1963 Corvette: Chevrolet Advance Information: Engine Crankcase Backfire

Subject: Engine Crankcase Backfire

Model and Year: All 1963 Corvettes Except Fuel Injection

Bulletin Number: #AI-63-10

1963 CORVETTE AIR CLEANER BASE

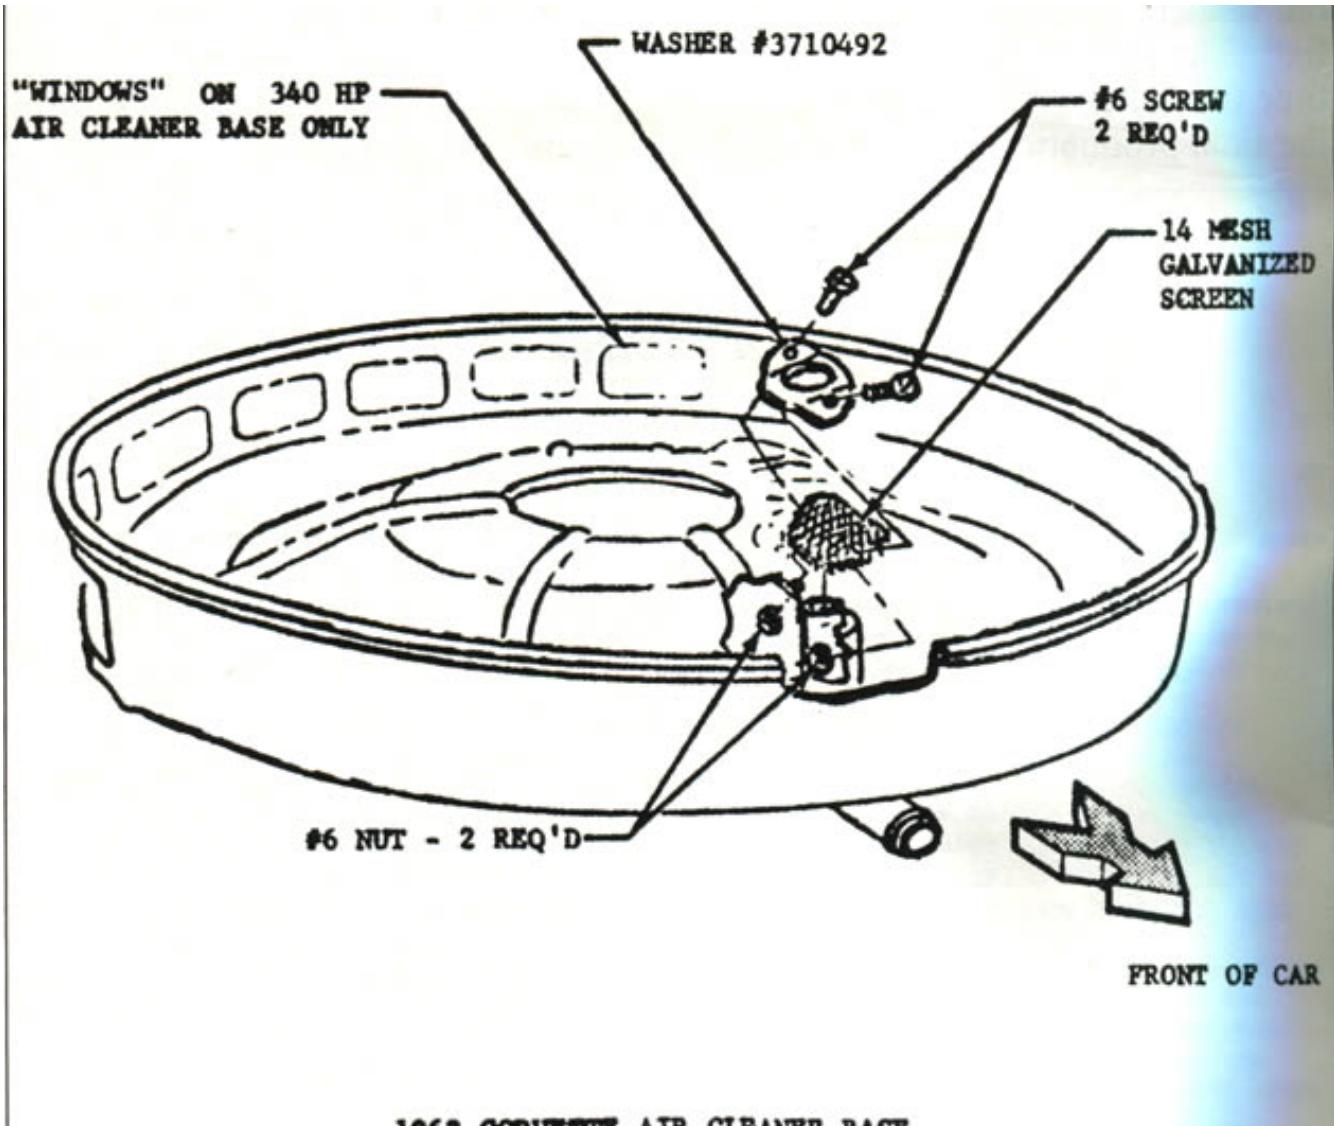
An accidental carburetor backfire during severe cold-weather starts, may result in a flame traveling down the air cleaner to crankcase vent fresh air supply tube, igniting the fumes in the crankcase. In extreme cases, the resulting explosion may damage the oil pan and rocker covers.

A final production correction has not been determined at this time; however, installation of a flame arrestor screen to the inside of the air cleaner (as illustrated on the attached sheet) will prevent re-occurrence of this condition.

Using 14 mesh galvanized screen, cut a circle approximately 1-1/2" in diameter and solder around outer edge of screen to prevent individual wires from being sucked into the engine.

Bend brake anchor pin washer Part No. 3710492, to fit contour of air cleaner. Position washer and drill two (2) 5/32" diameter holes through washer and air cleaner base. Place galvanized screen under washer and secure with two (2) #6 screws and nuts.

NOTE : Ends of screws must be cut short and "peened" over nut to keep engine vibration from loosening screws, allowing them to be swallowed through the carburetor.
